**CEDAR CREEK STREAM AND WETLAND RESTORATION  
PROJECT  
MONITORING REPORT  
MONITORING YEAR 3  
FINAL**

SAMPSON COUNTY, NORTH CAROLINA  
CONTRACT No. 005011 - PROJECT No. 95718  
USACE ACTION ID No. 2012-00389 – NCDWR PROJECT No. 2013-0186

RE: Cedar Creek Stream and Wetland Restoration Site: MY3 Monitoring Report  
(NCDMS ID 95718)

Listed below are comments provided by DMS on January 31, 2018 regarding the Cedar Creek Stream and Wetland Restoration Site: Year 3 Monitoring Report and RES' responses.

Figure 3. Current Conditions Plan View Map (CCPV)

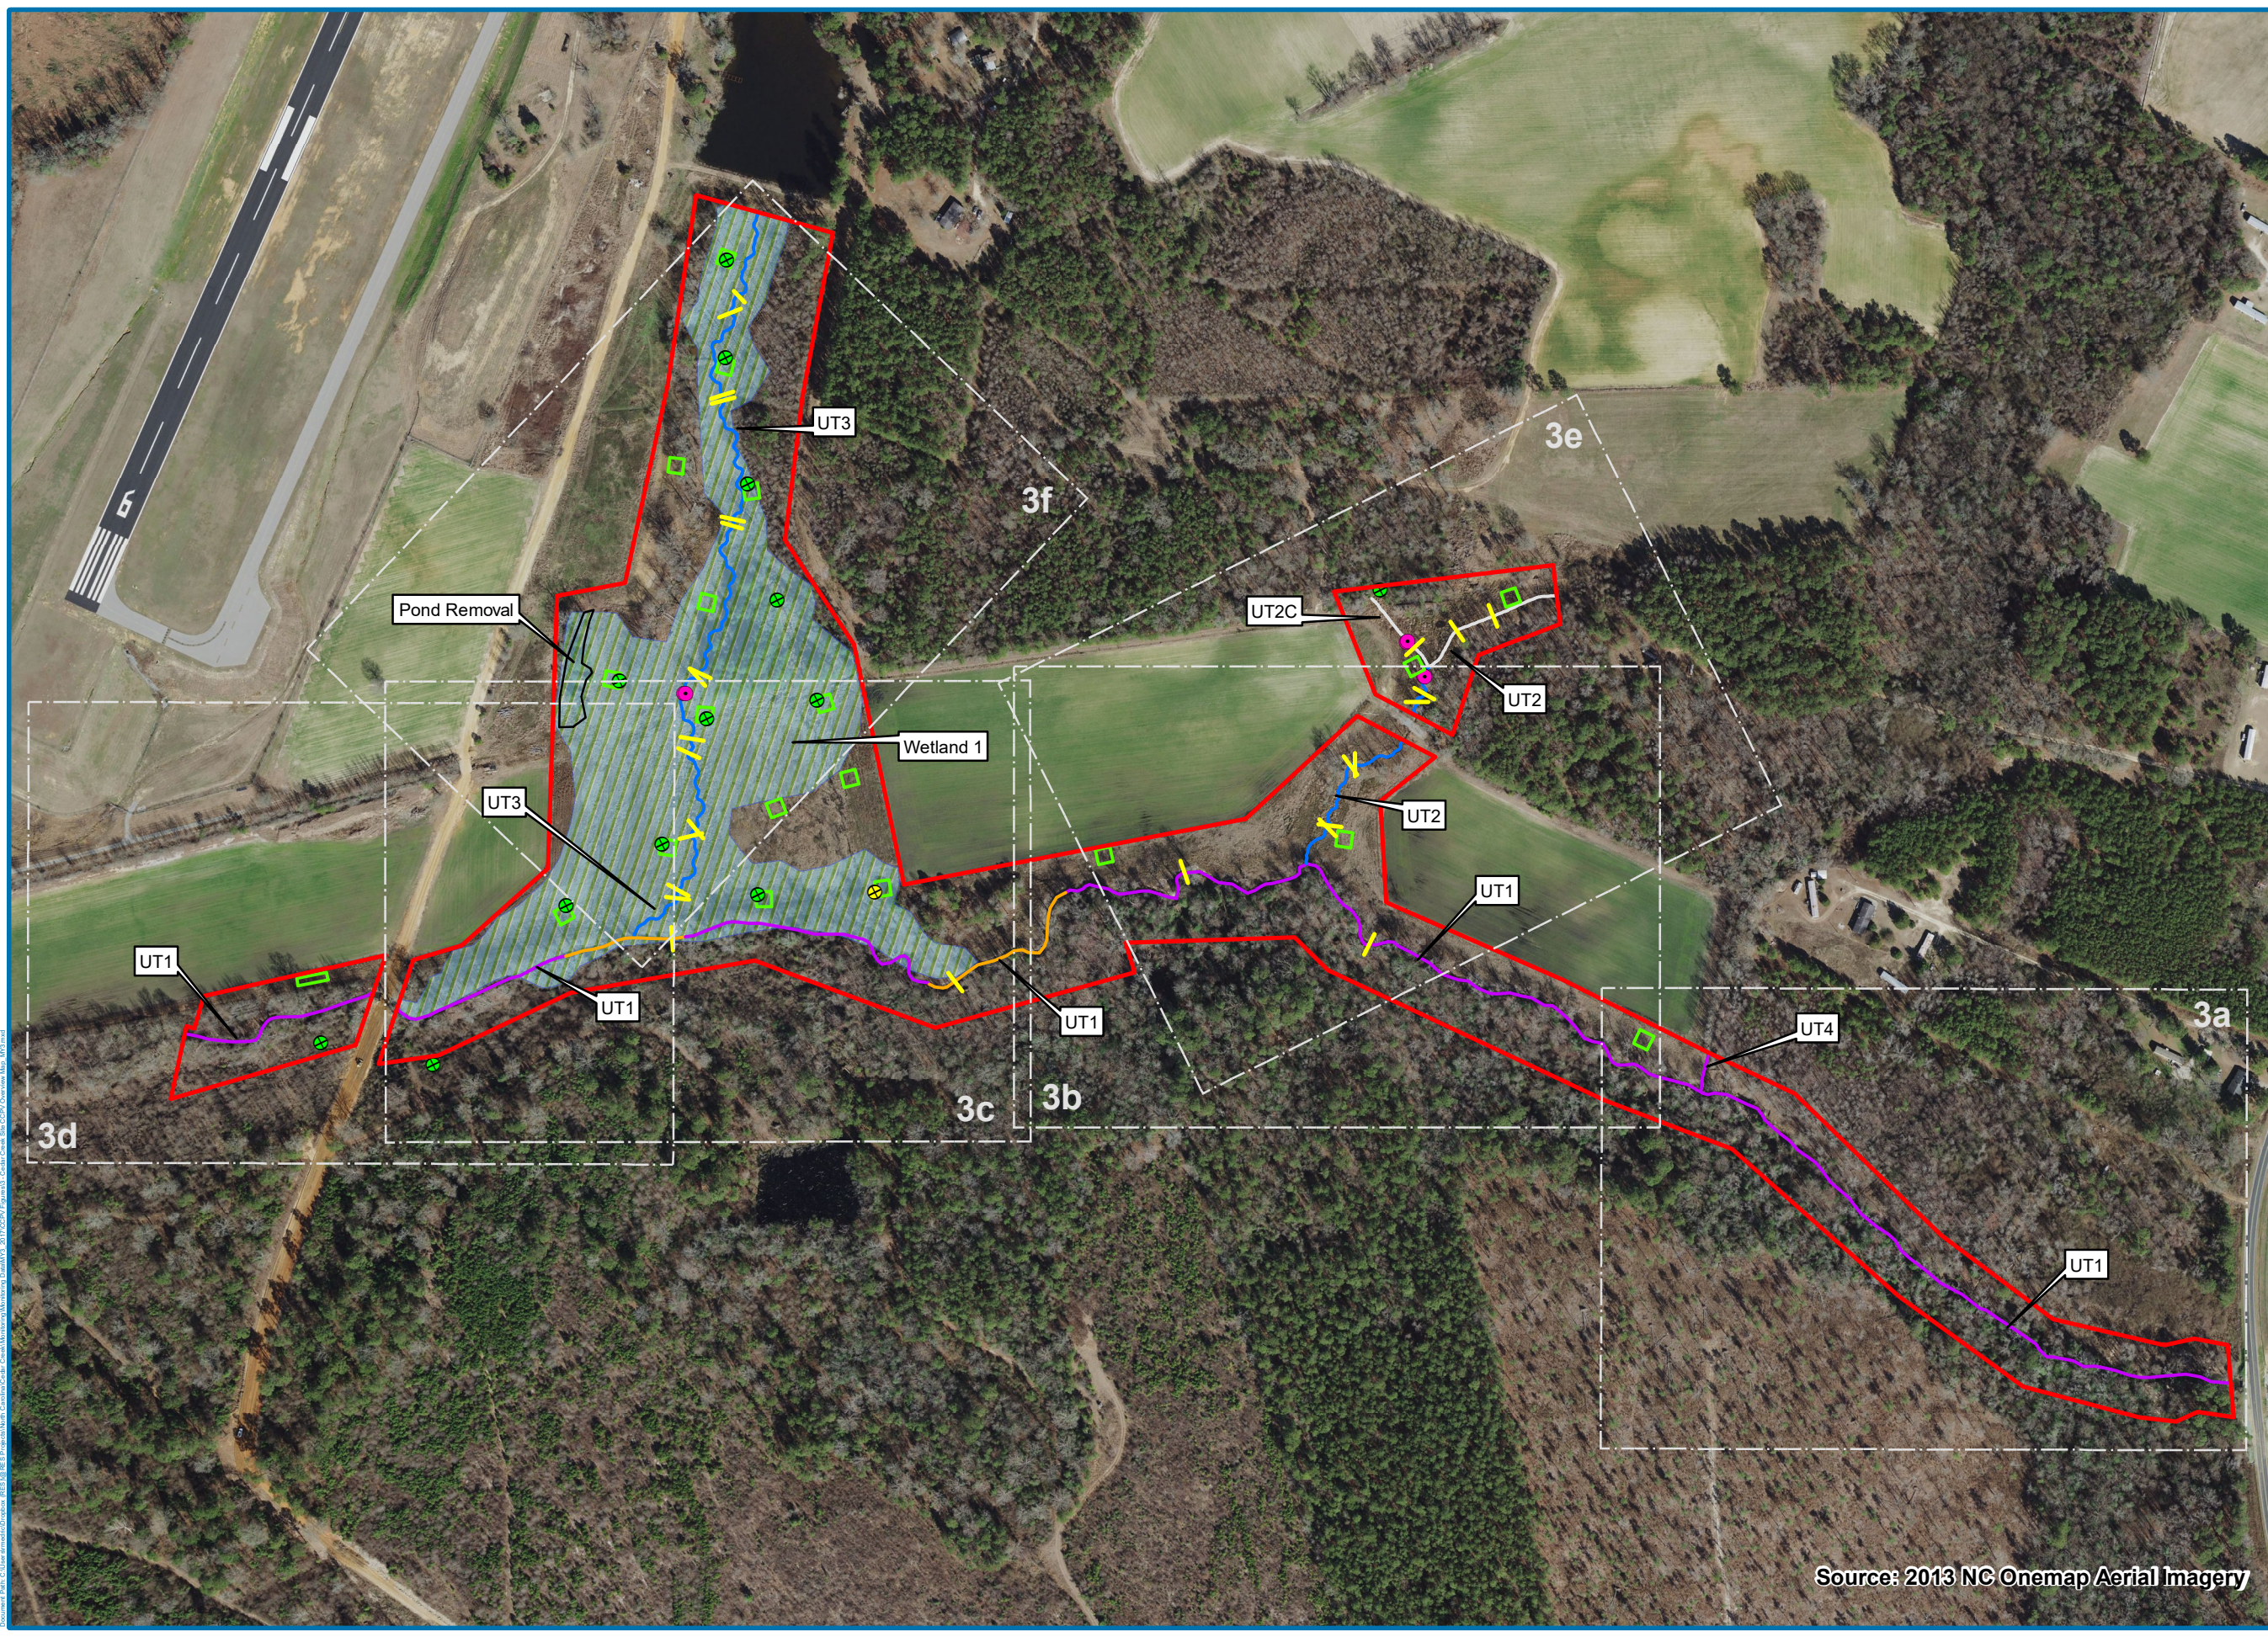
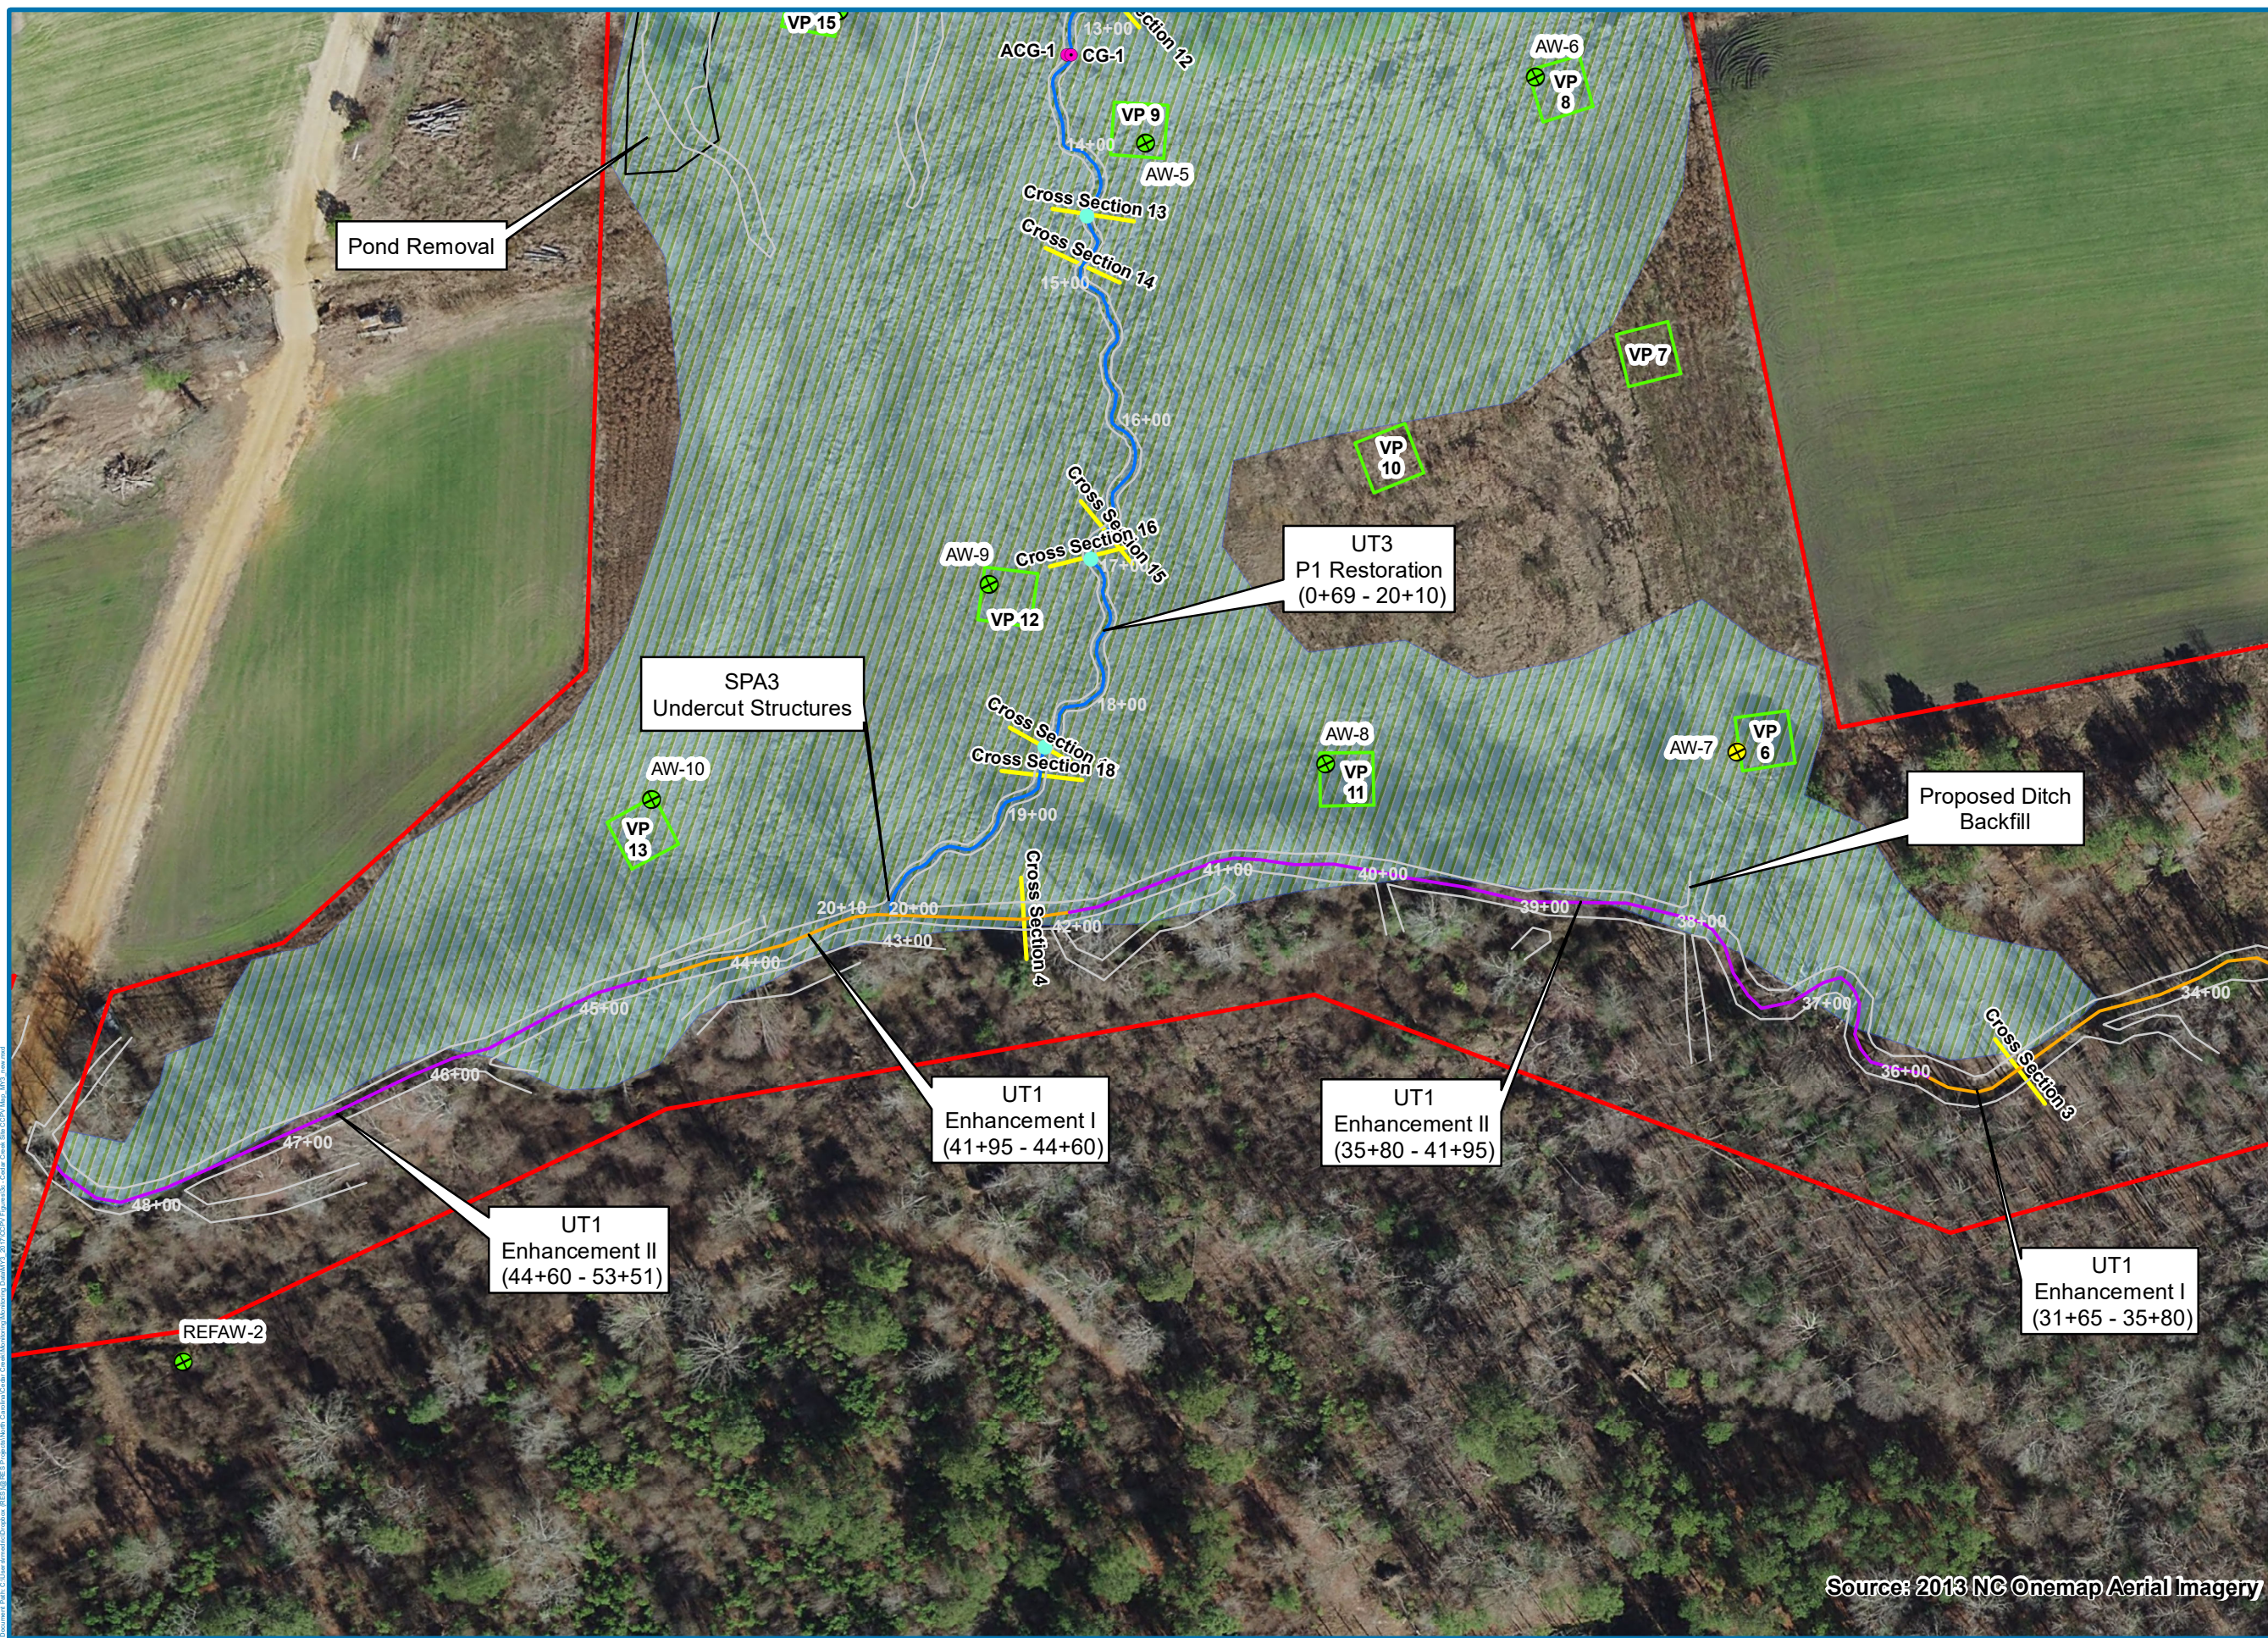
Appendix B, CCPV:

a. Figures 3a through 3f: Use consistent symbology in the Legends for each figure.

b. If there are four SPAs, show SPA4 on the appropriate figure.

c. The locations of bank pins are not shown. Please show on appropriate figure(s).

[Done.](#)
